Office Action Summary

10/816,245

STROBEL, LARRY A.

DETAILED ACTION

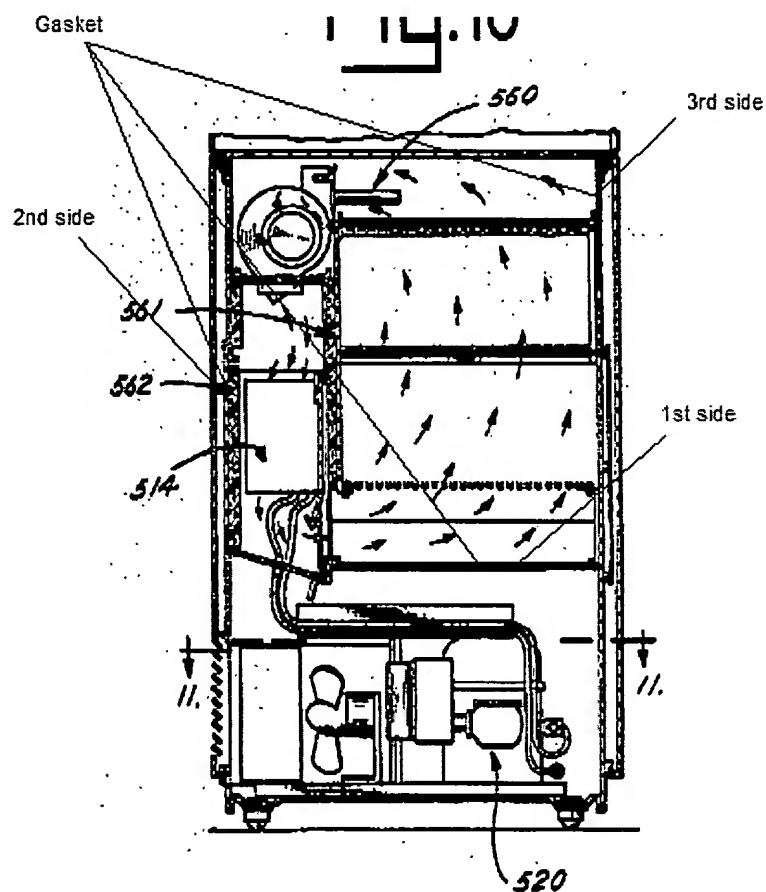
With respect to claim 1, Anderson et al. teaches a computer system comprising: a cabinet (402) having a closure configured to be substantially airtight when closed; a personal computer (Comprising the CPU, motherboard, and other circuit boards) positioned within the cabinet (Via the card cage (416, 417, 419, 423) a gasket (561) positioned in a space between an inner surface of the cabinet (Adjacent 562) and an outer surface of the personal computer configured to prevent passage of air through the space between the personal computer and the inner surface of the cabinet between a

first region and a second region (The gasket (561) prevent the warm hot air of the first region from entering the second region (Where the PC is located)); and a cooling unit (514) positioned within the cabinet, the cooling unit configured to draw air from the first region of the cabinet (Between the fan and the evaporator), cool the air and output the air into the second region of the cabinet (Where the PC is located).

With respect to claim 9, Anderson et al. further teaches a gasket (See present office action Fig 1 below) configured to substantially seal a space between an interior of surface of the enclosure and the exterior of the personal computer case, on three sides of the case.
